1A & 1B VALLEY ROAD
59 - 63 TRAFALGAR AVENUE
LINDFIELD

SSD APPLICATION - DESIGN REPORT

APPENDIX AP6. RTS RFI RESPONSE

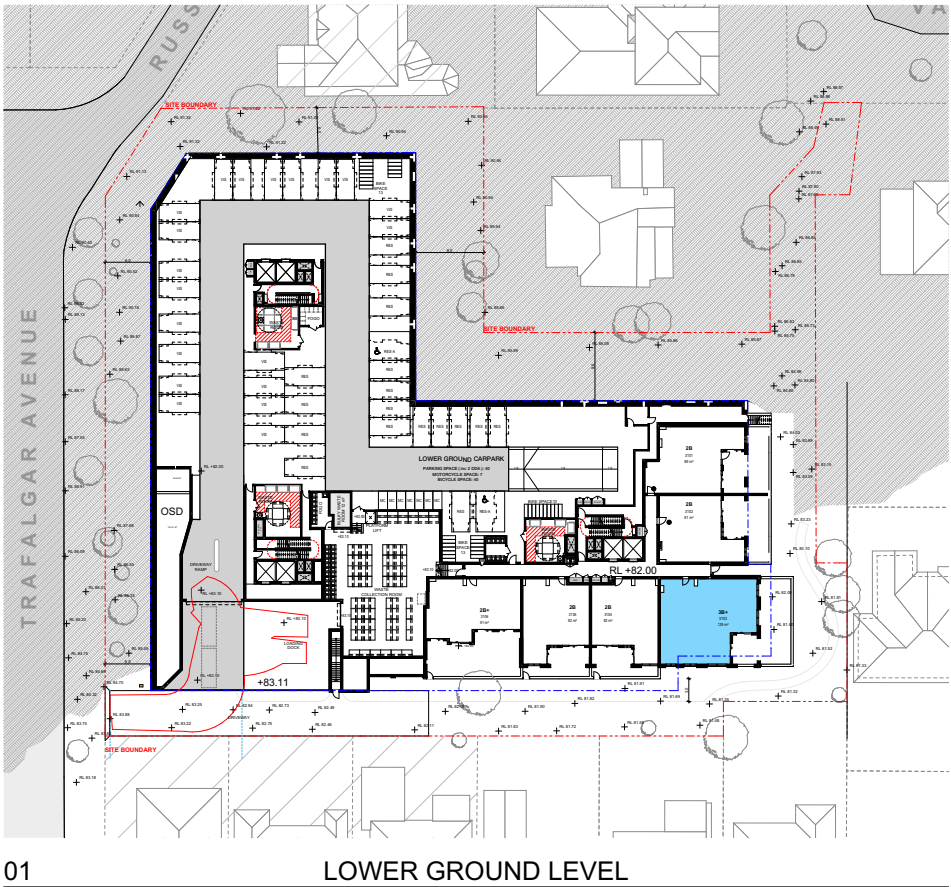
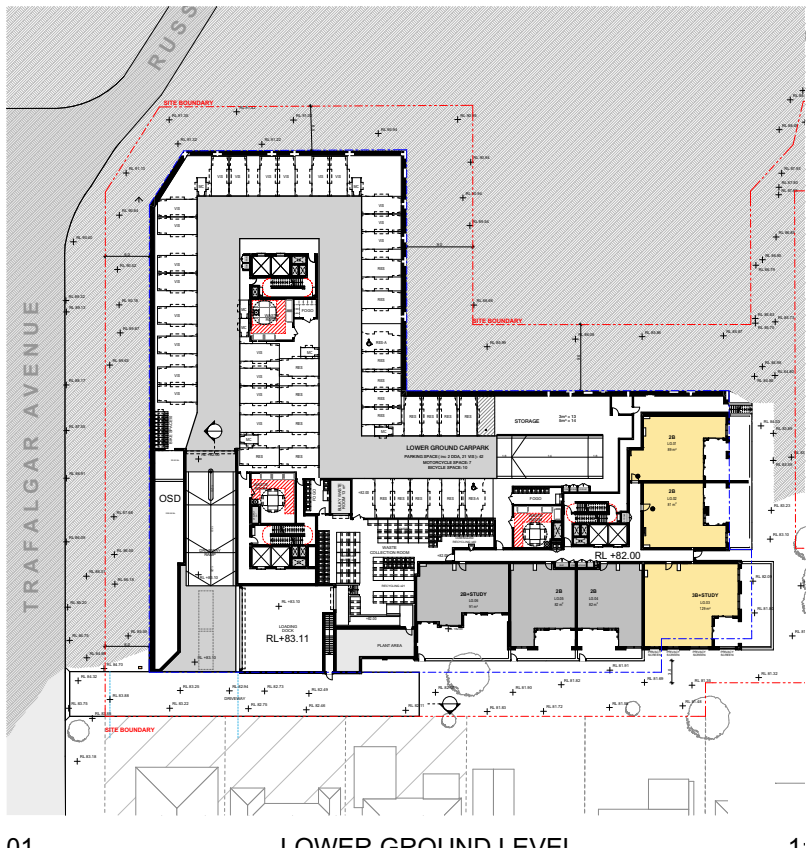
- f. Demonstrate that the apartments located on the lower ground floor will have adequate amenity including solar access, cross ventilation and visual privacy.

AFFORDABLE HOUSING

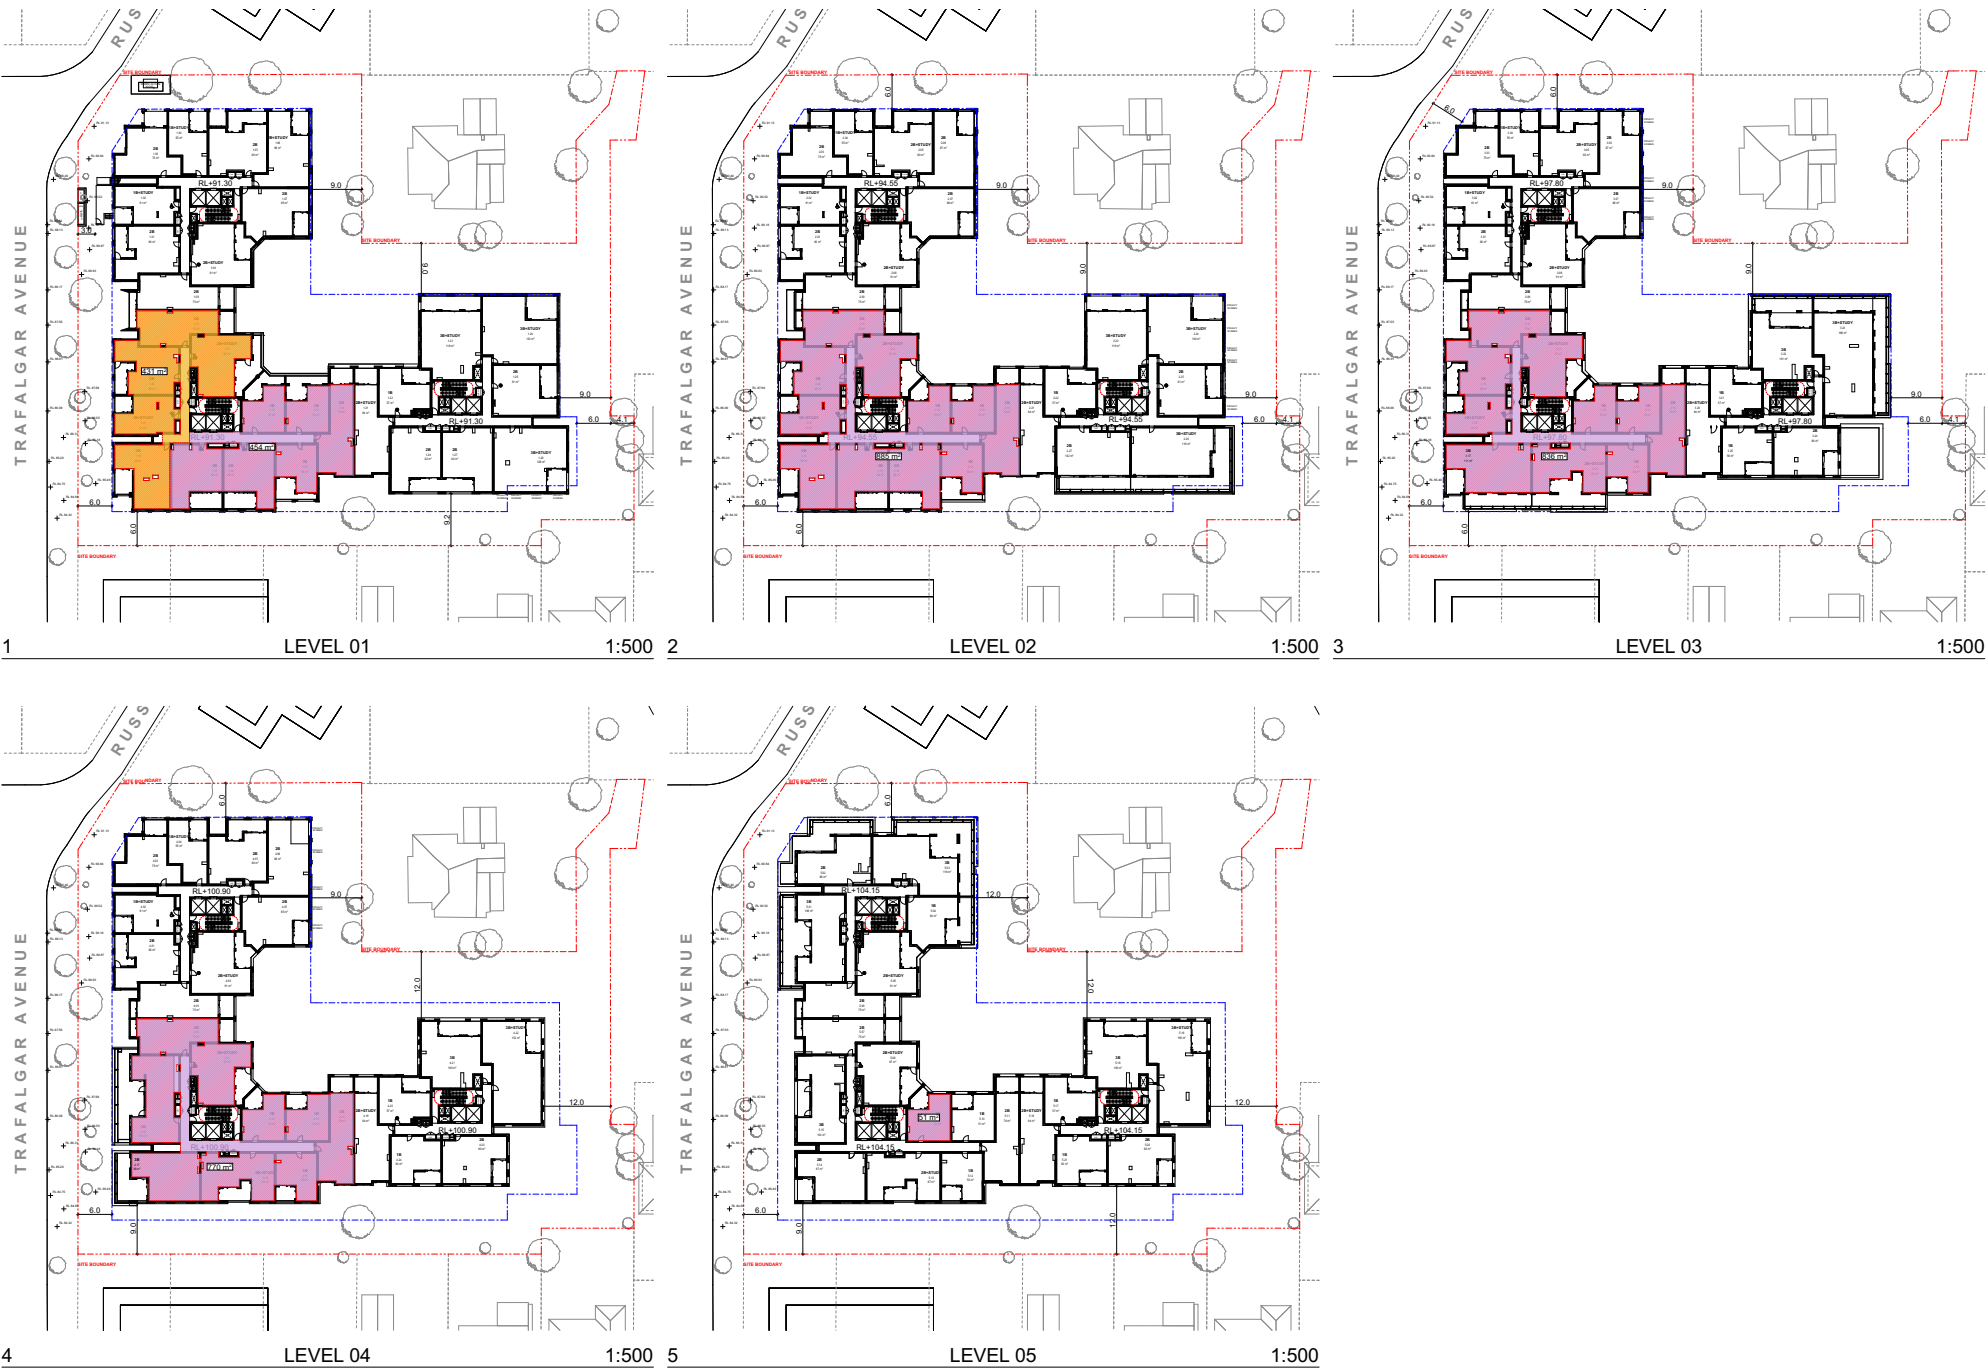
- 22. Demonstrate that the affordable housing apartments will have good level of amenity in terms of key ADG criteria and the “Residential amenity of affordable housing” section (p15) of the In-fill Affordable Housing Practice Note.
- 24. Confirm the amount of affordable housing. There are discrepancies in the figures for TOD affordable housing and in-fill affordable housing set out in the EIS and drawing DA403.

The amended layout includes 43 affordable units out of 212 apartments, located in Building B. The design of these units has been optimised to maximise solar access and cross ventilation, ensuring that a high level of amenity is generally achieved throughout the development. Additionally, the proposal includes additional amenity to to affordable housing through the provision of larger units, some with the inclusion of a dedicated study area, and capability of being adapted into accessible units.

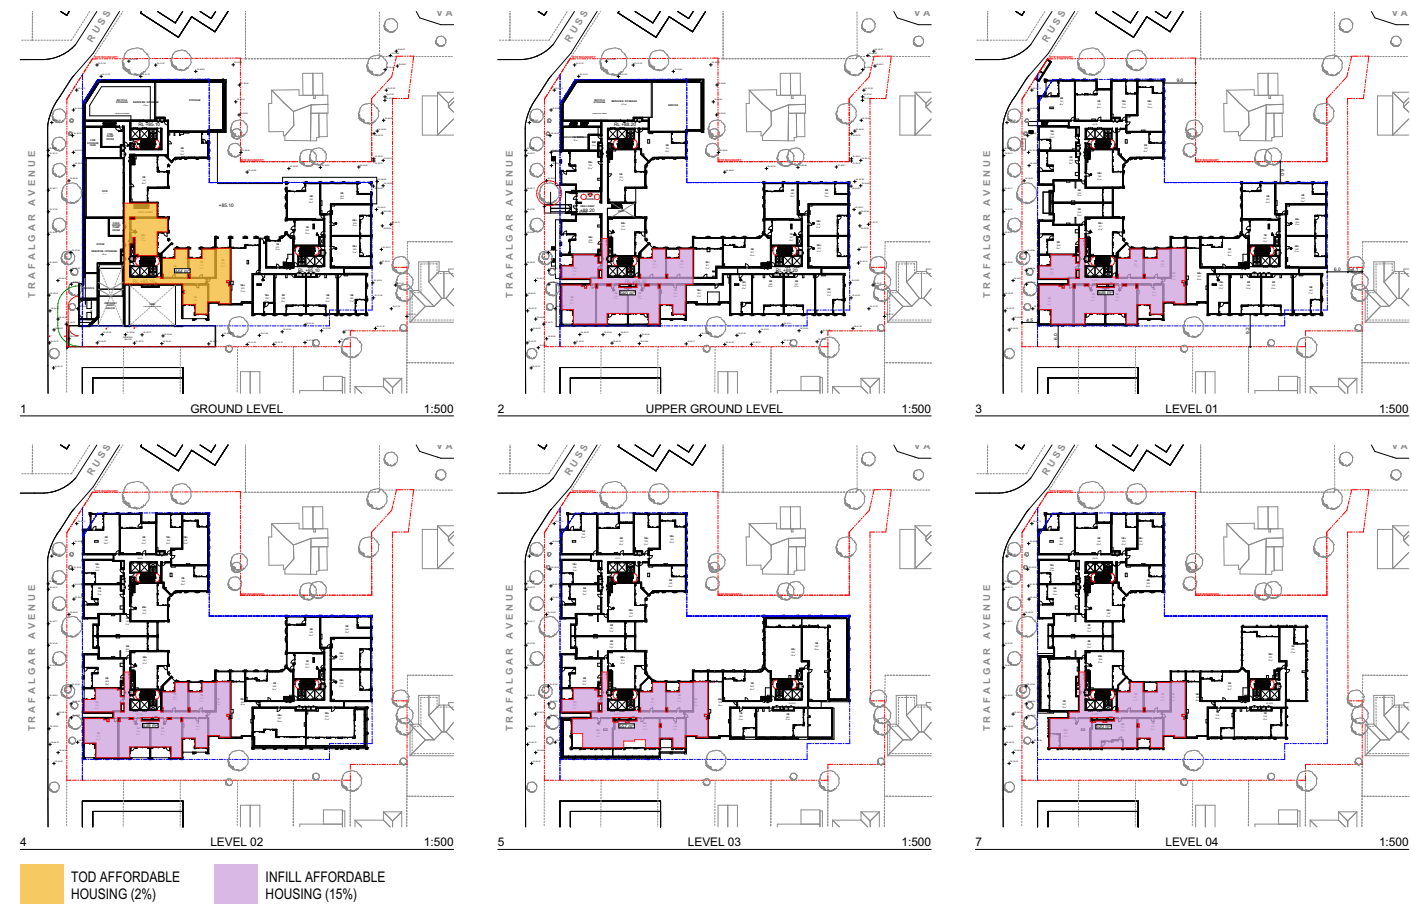
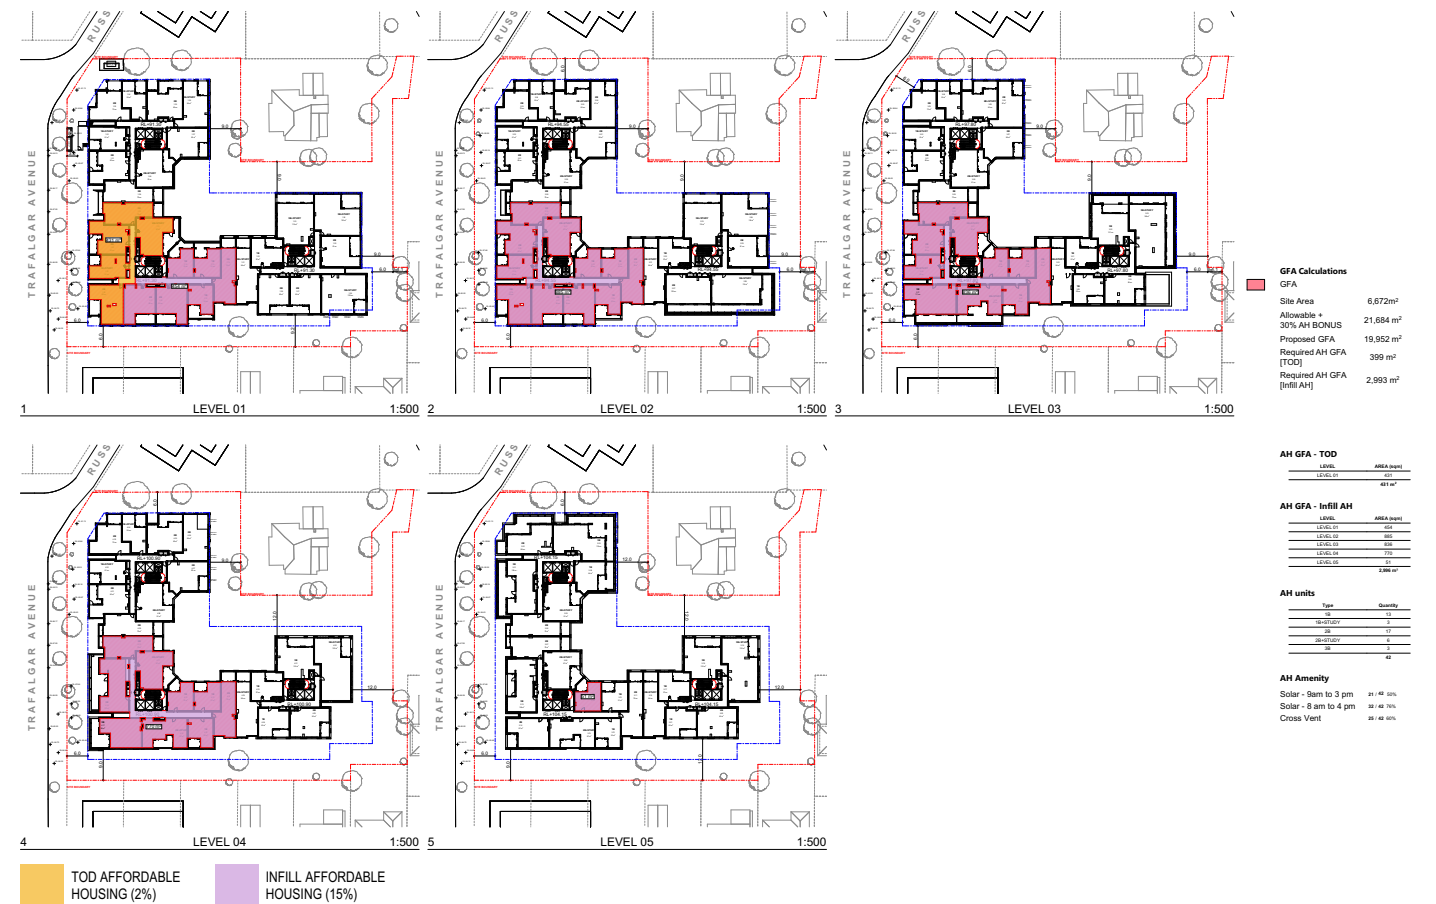
23. Provide revised plans and calculations which demonstrate the allocation of corridor areas to affordable housing is appropriately apportioned, based upon the floor area of market and affordable housing on that respective level.

Revised plans and calculations have been prepared to demonstrate that corridor areas are appropriately apportioned between market and affordable housing, based on the relative floor areas of each on the respective levels. This ensures equitable access and circulation for all residents while maintaining compliance with relevant design guidelines.

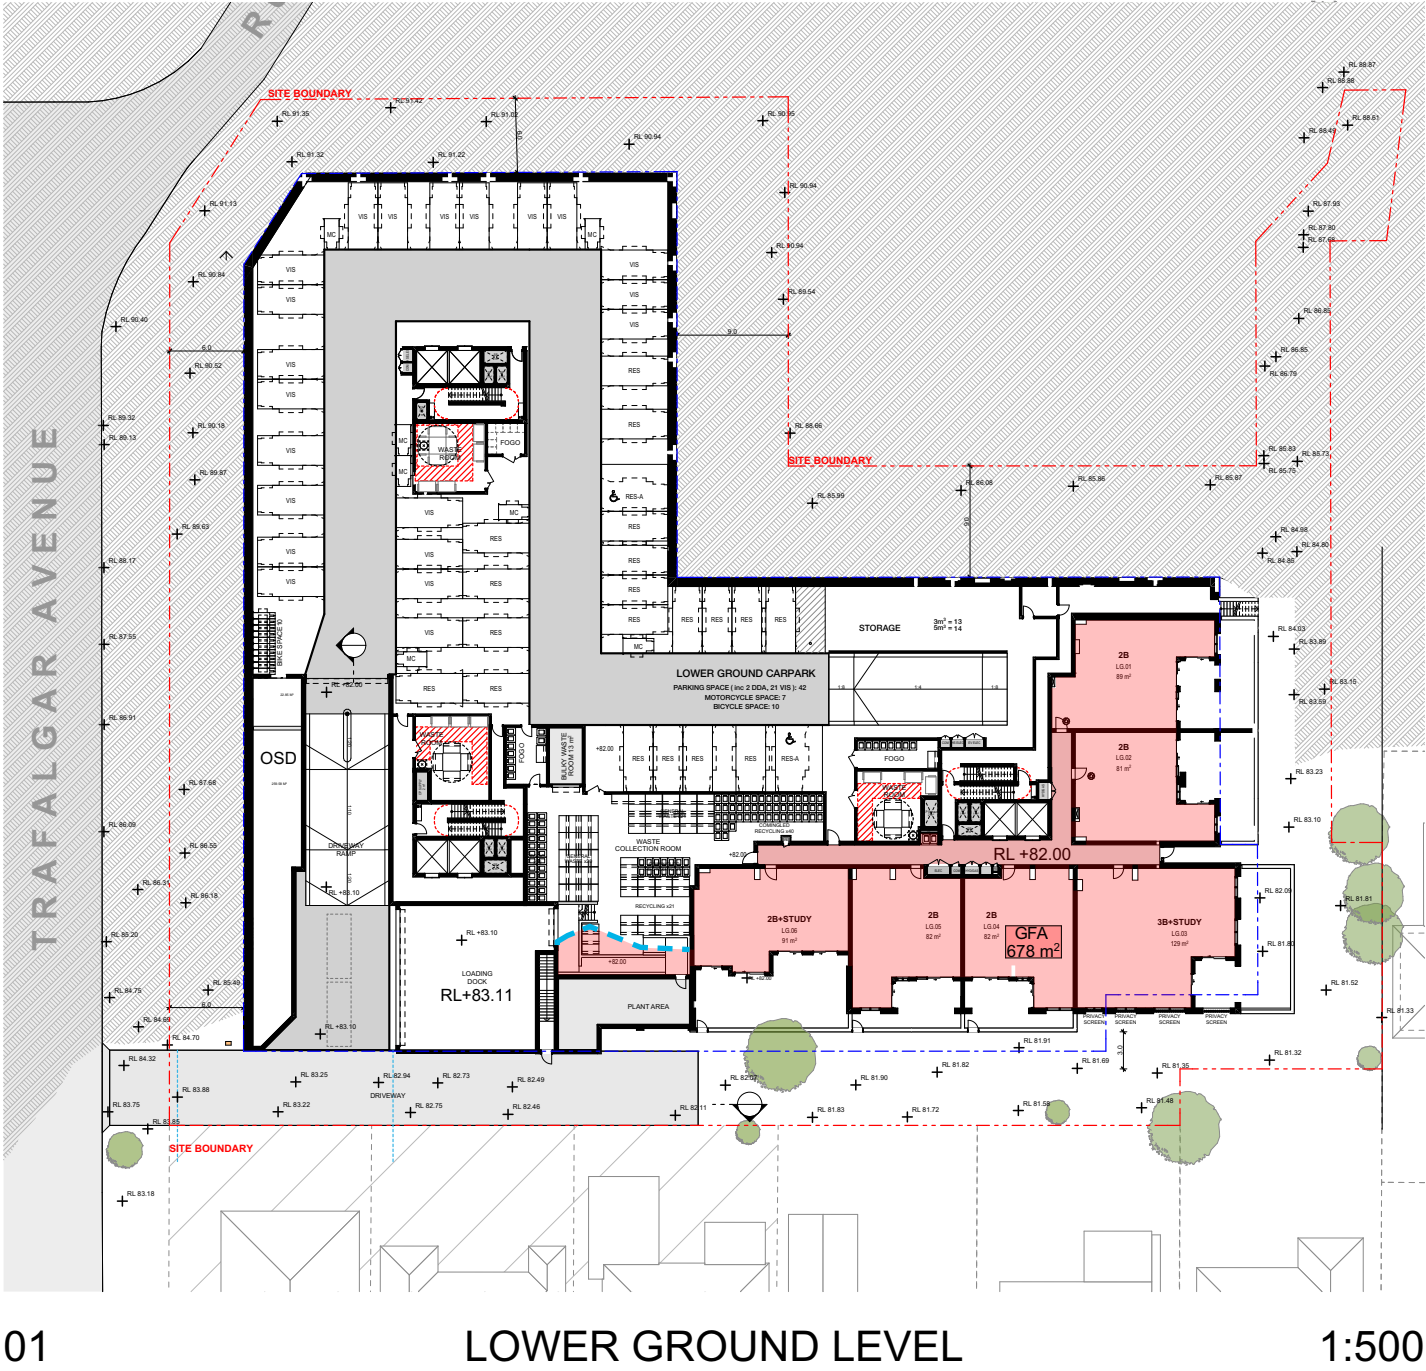
25 - f. confirm the proposed gross floor area has been calculated in line with the definition under the Ku-ring-gai Local Environmental Plan 2015

The gross floor area has been calculated in accordance with the definition under the Ku-ring-gai Local Environmental Plan 2015. The basement area has also been defined and accounted for consistently with the relevant provisions.
Refer Architectural Drawing DA400 & DA401.
